**BEFORE THE PUBLIC UTILITIES COMMISSION
OF THE STATE OF CALIFORNIA**

Rulemaking 14-10-010
(Filed October 16, 2014)

**CALIFORNIA INDEPENDENT SYSTEM OPERATOR CORPORATION
REPLY COMMENTS**

Updated Figure 6

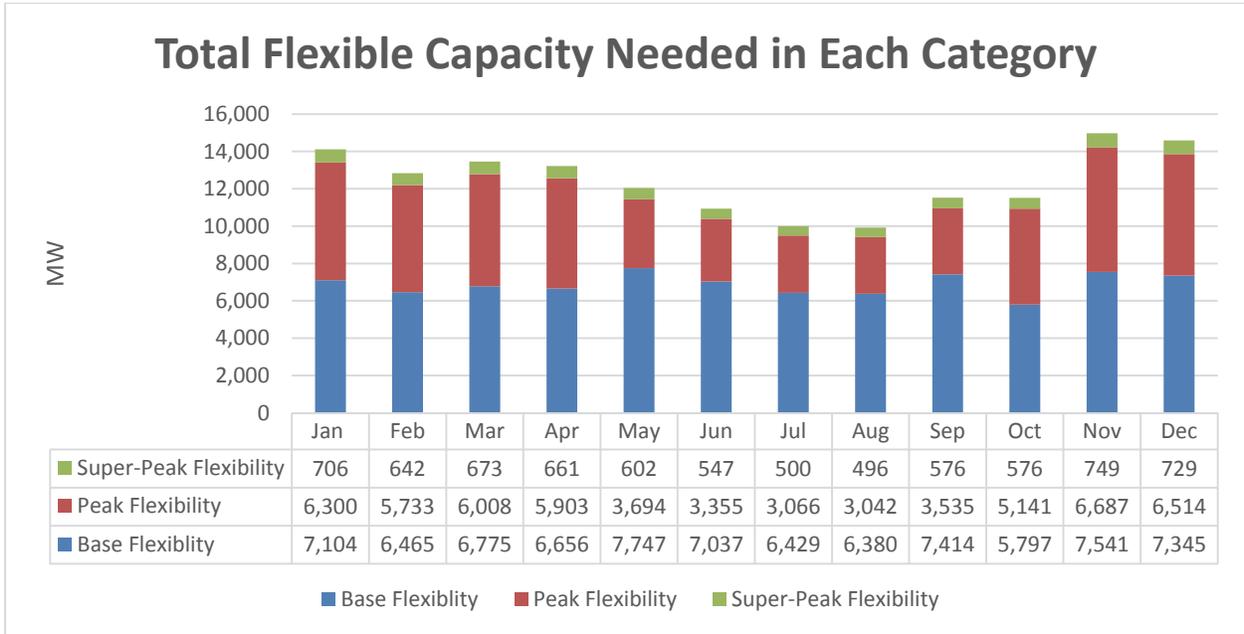
TURN correctly notes that Figure 6 of the FCR report was not correctly updated to reflect changes made in response to Energy Division staff's stakeholder comments. The CAISO has provided an updated Figure 6 below.

The CAISO will amend its posted FCR report to correct Figure 6.
